MONTGOMERY COUNTY HISTORIC PRESERVATION COMMISSION
STAFF REPORT

Address:	5816 Surrey St., Chevy Chase	Meeting Date:	4/10/2018
Resource:	Secondary (Post-1915) Resource (Somerset Historic District)	Report Date:	4/3/2018
		Public Notice:	3/28/2018
Applicant:	Neal Thompson	Tax Credit:	Yes
Review:	HAWP	Staff:	Michael Kyne
Case Number:	35/36-18B		
PROPOSAL:	Roof replacement, siding replacement, and patio alterations

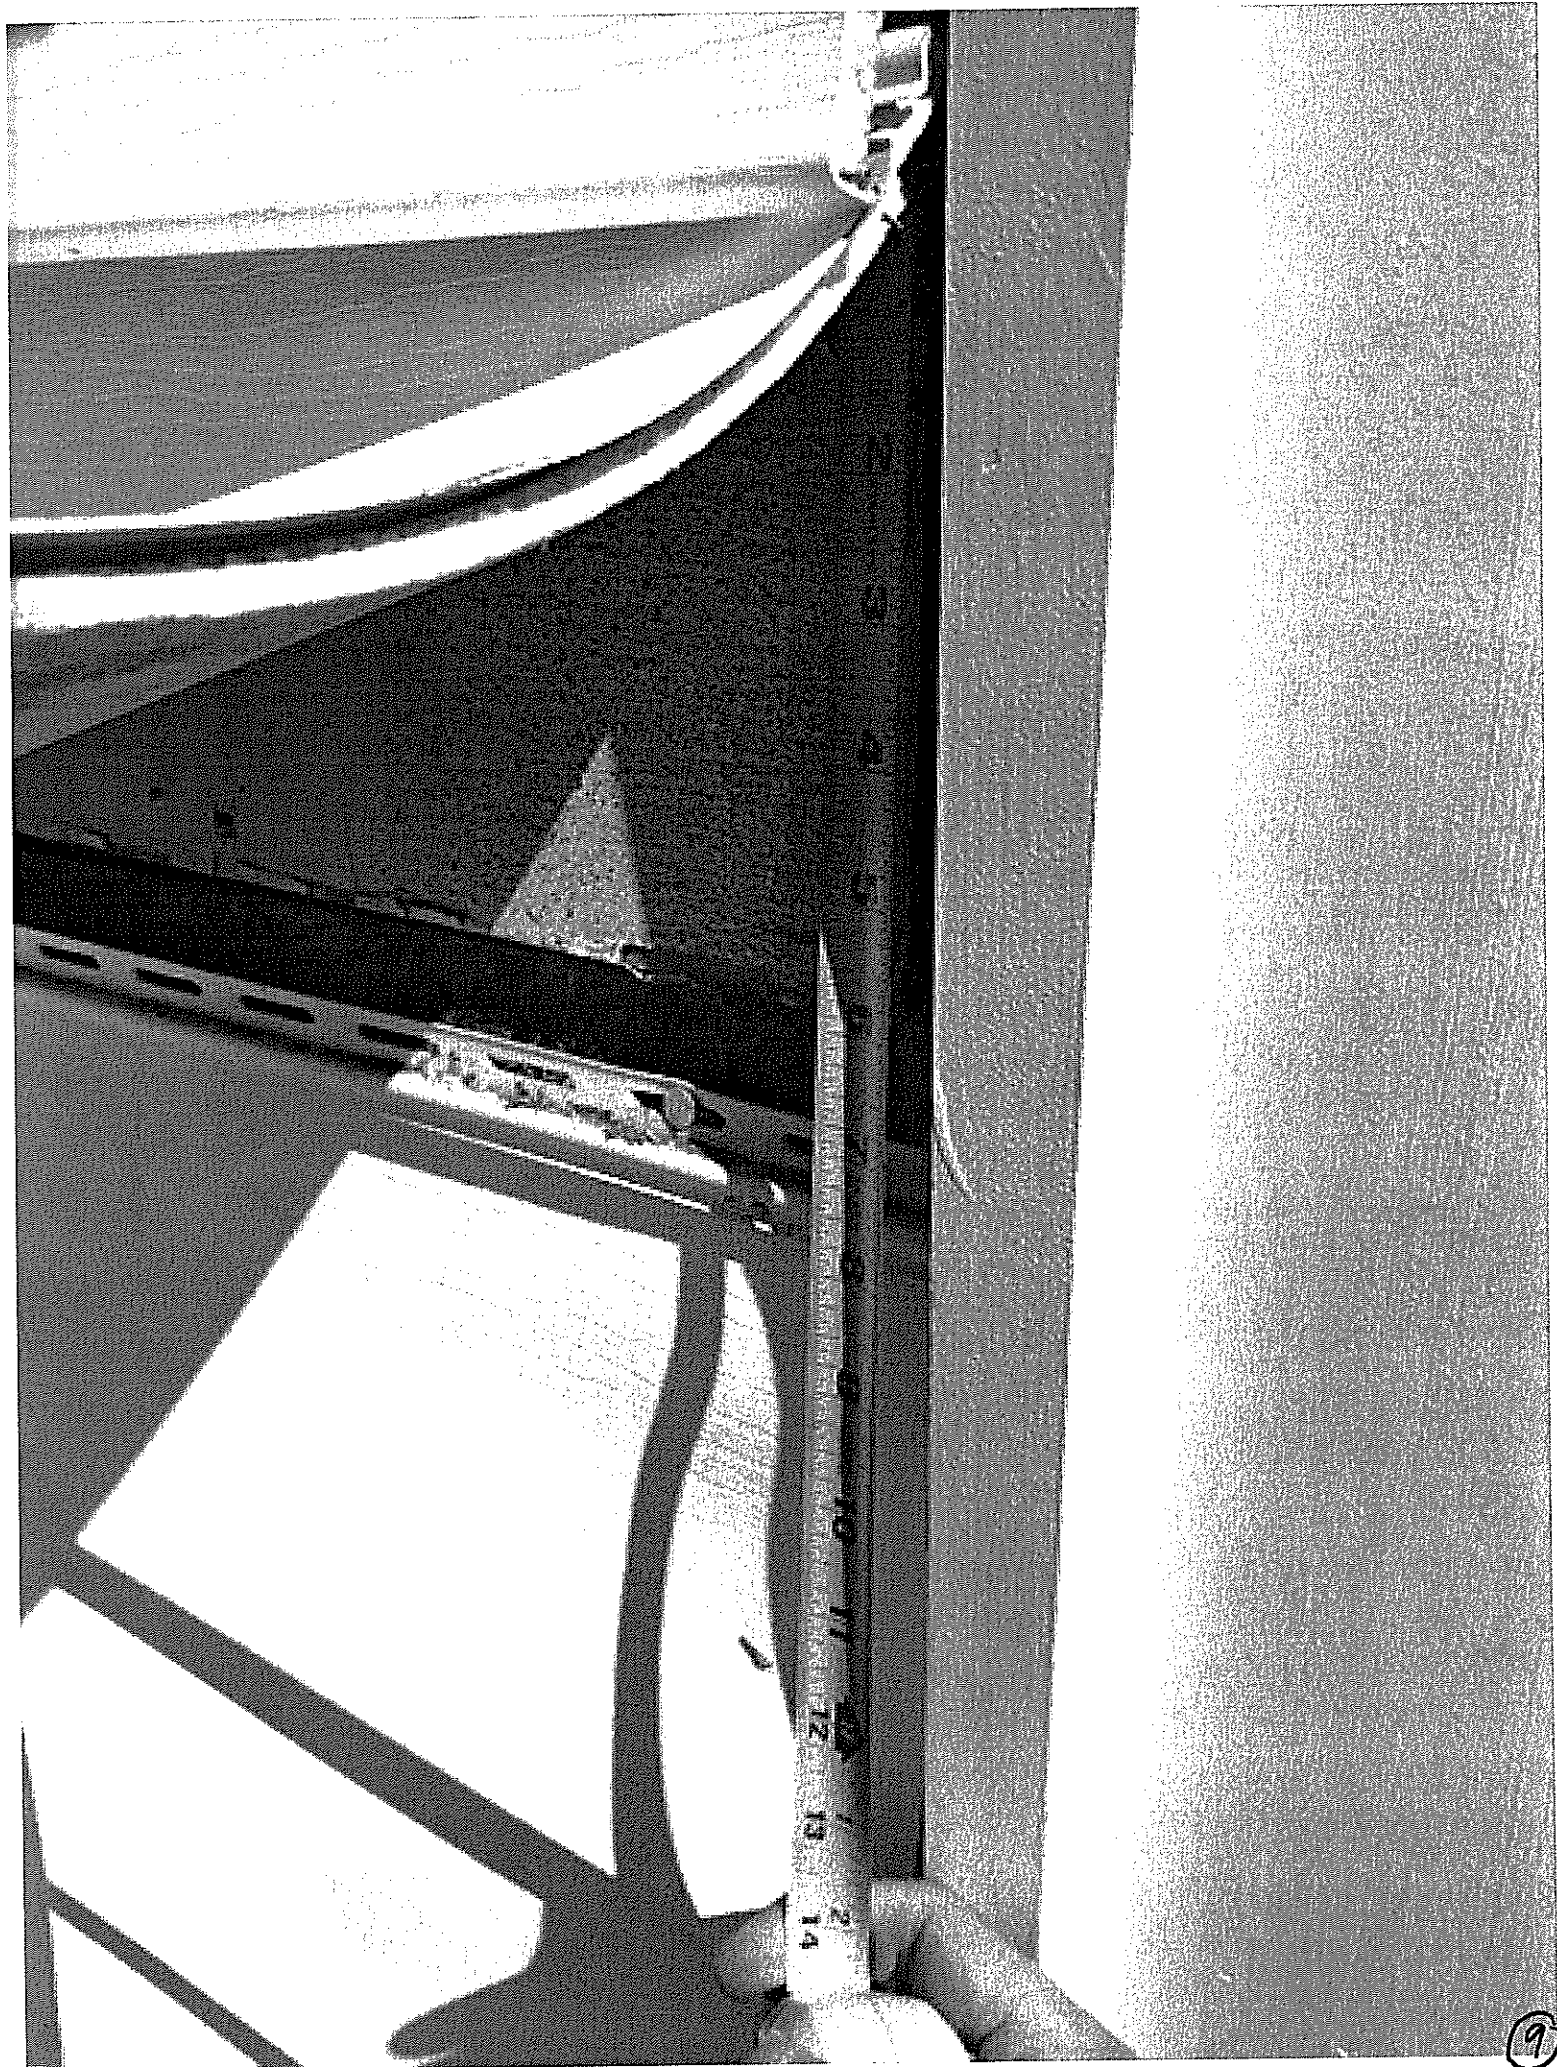
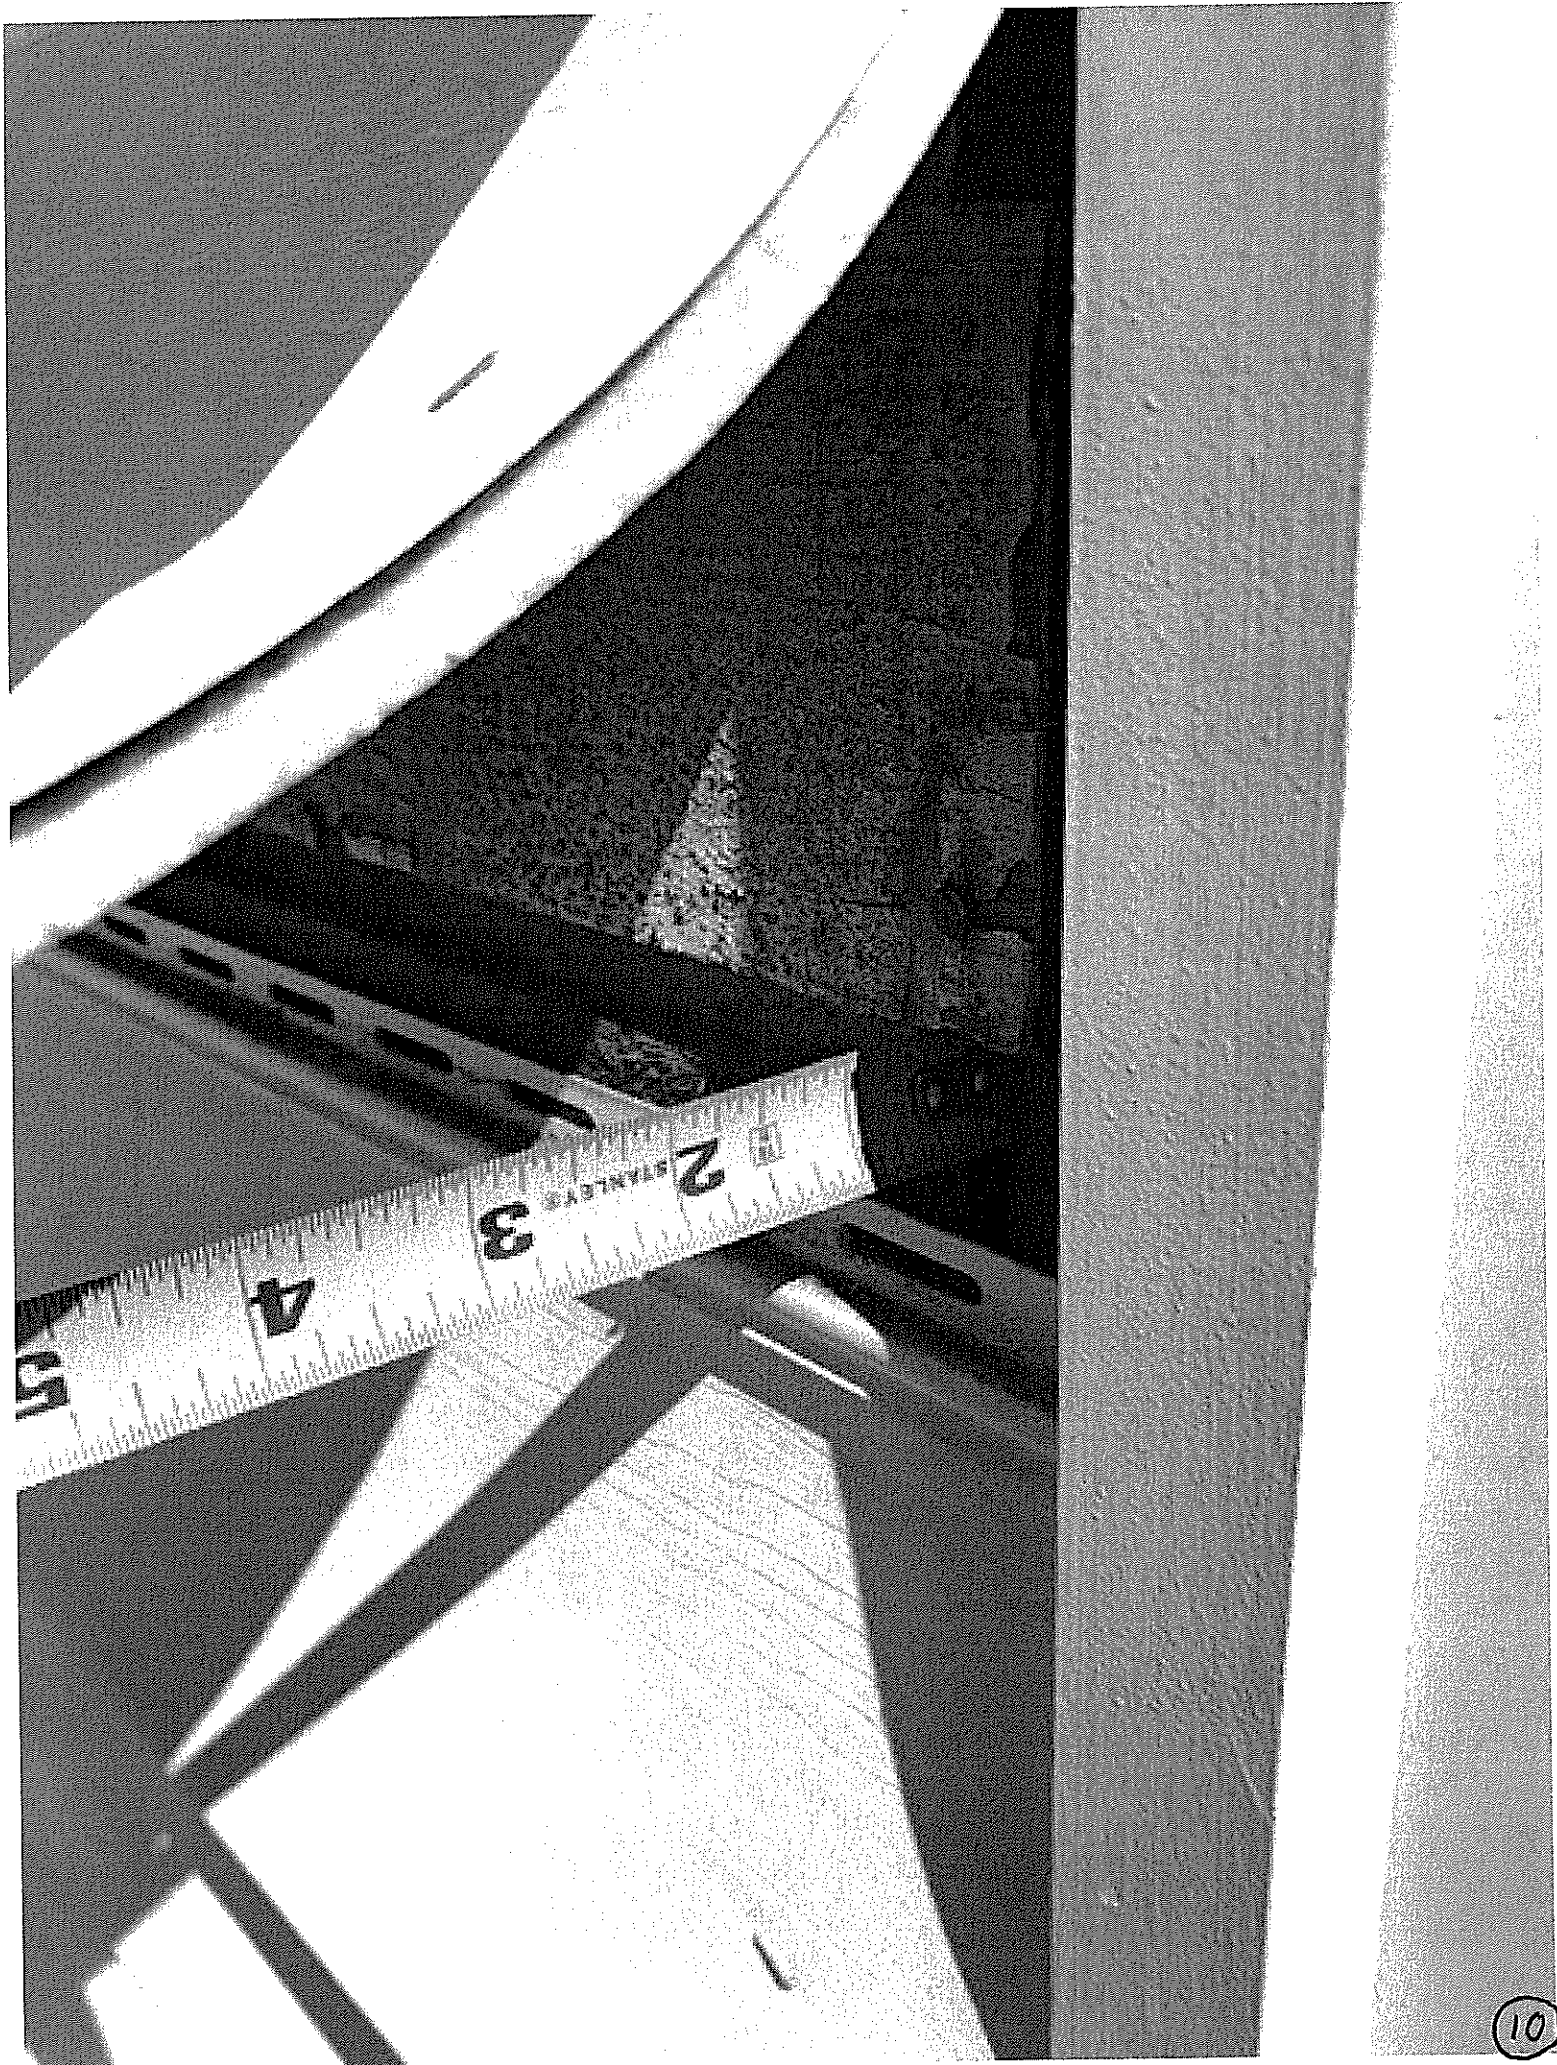
I'm going to remove a portion of the vinyl in two areas on the house - one area showing what appears to be original footprint, and a second on an addition that was done in the 80's. From what I can tell, there exists old wood siding at the original house areas (but in very bad shape as you will see from the pics. Some of the siding appears to be face nailed, and there is significant rot and decay. I also do not believe there is adequate sheathing behind the original siding, so it would have to be removed regardless). At the newer 80's addition, there is no older material behind. I'm assuming when the 80's addition was done they put up the vinyl and covered the rest of the existing in the same material. I'm attaching here a few photos from my exploration. I would propose matching the existing siding exposure and lap dimension to stay consistent with the original material, specifying a western red cedar siding that is painted. Assume that is what you all would prefer as well. I think the existing material that I see is a cedar material as well.

Attached pics show the vinyl pulled back at an original area of the house with tape measure showing a 6" siding exposure, and 1/2" lap dimension.

1. The original wood siding on the historic house will be repaired, not replaced.

Staff fully supports the removal of the vinyl siding from the historic house and the replacement of vinyl siding with wood siding on the existing rear additions, as this will reverse previous incompatible alterations; however, staff recommends that the Commission approve the applicant's proposal with the condition that the original wood siding on the historic house will be repaired rather than replaced, which is in accordance with *Standard #6*. Once the vinyl siding is removed, the condition of the original wood siding can be fully investigated. If the applicant can successfully demonstrate to staff that the original wood siding is beyond repair, staff will present this information to the Commission as a staff item revision.

LEFT ELEVATION - FIRST FLOOR KITCHEN WINDOWS
(2) Double Hung Windows at 31.5" wide x 41" tall
PROPOSED SIZE - (2) @ 31.5" wide x 41" tall
Lite pattern to match existing

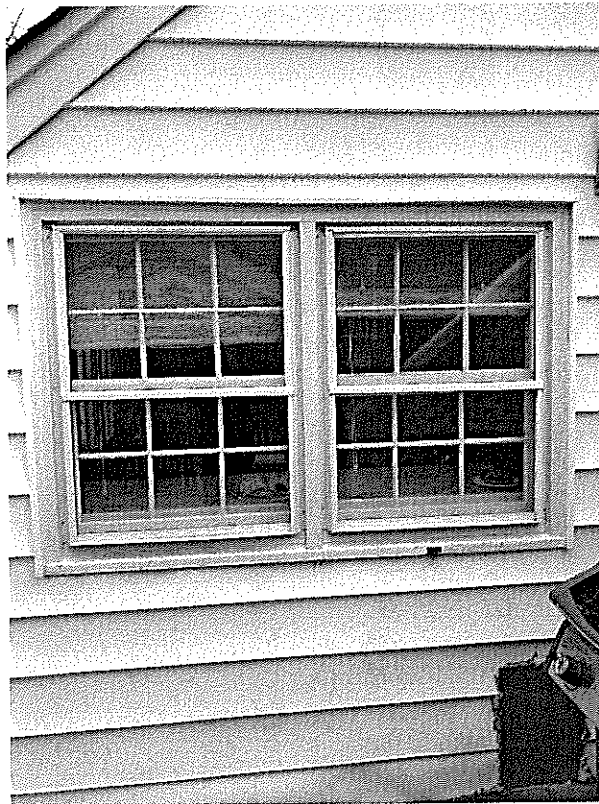
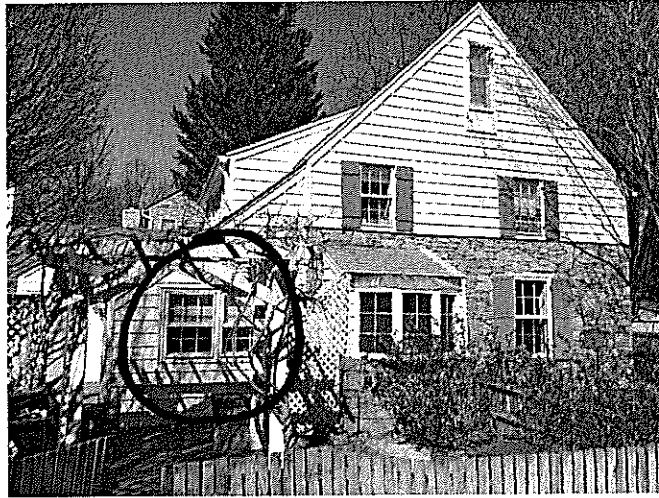
- Paired 6-over-6 wood double-hung windows on the left side of an existing rear addition (see Circle 14).
- Four ganged 6-lite wood casement windows on the rear/left side (as viewed from the front) dormer. This dormer is likely non-historic, as it is built on top of an existing rear addition (see Circle 15).
- Six ganged 6-lite vinyl casement windows on the rear/right side (as viewed from the front) dormer (see Circle 16).
- The 4-over-4 wood double-hung window in the left-side gable of the historic house (see Circle

Most of the windows to be replaced are on secondary elevations, where they are minimally visible from the public right-of-way, at best. The proposed new windows are consistent with the existing windows and with the Commission's requirements. Staff finds that the proposed window replacements are compatible with the subject property and historic district and will not detract from the character-defining features of the streetscape.

LEFT & RIGHT ELEVATION - ATTIC WINDOWS
(2) Double Hung Windows at 22" wide x 36" tall
PROPOSED SIZE - (2) @ 22" wide x 36" tall
Lite pattern to match existing

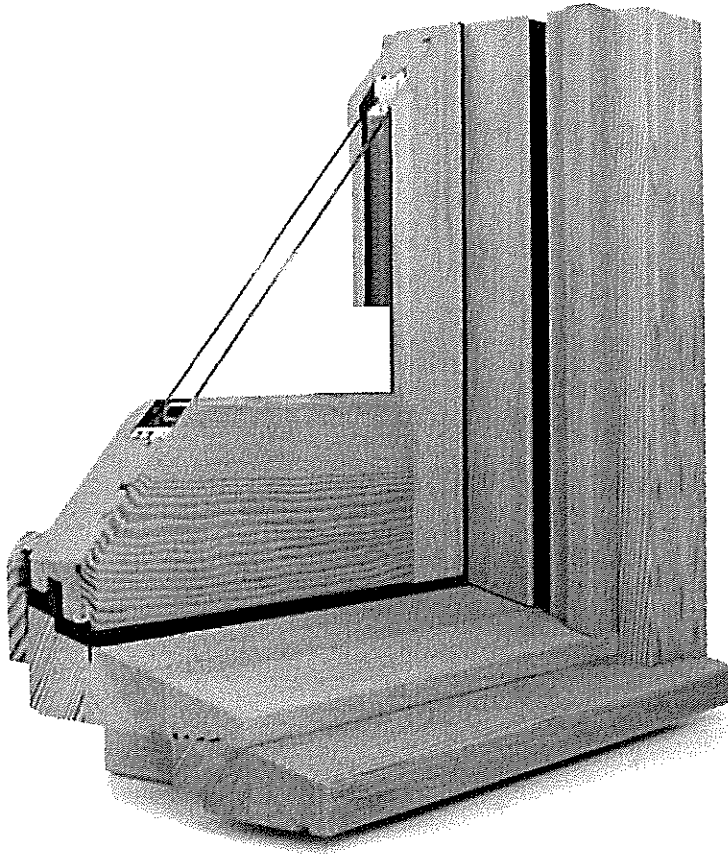
- 17).
The 4-over-4 wood double-hung window in the right-side gable of the historic house (see Circle 17).
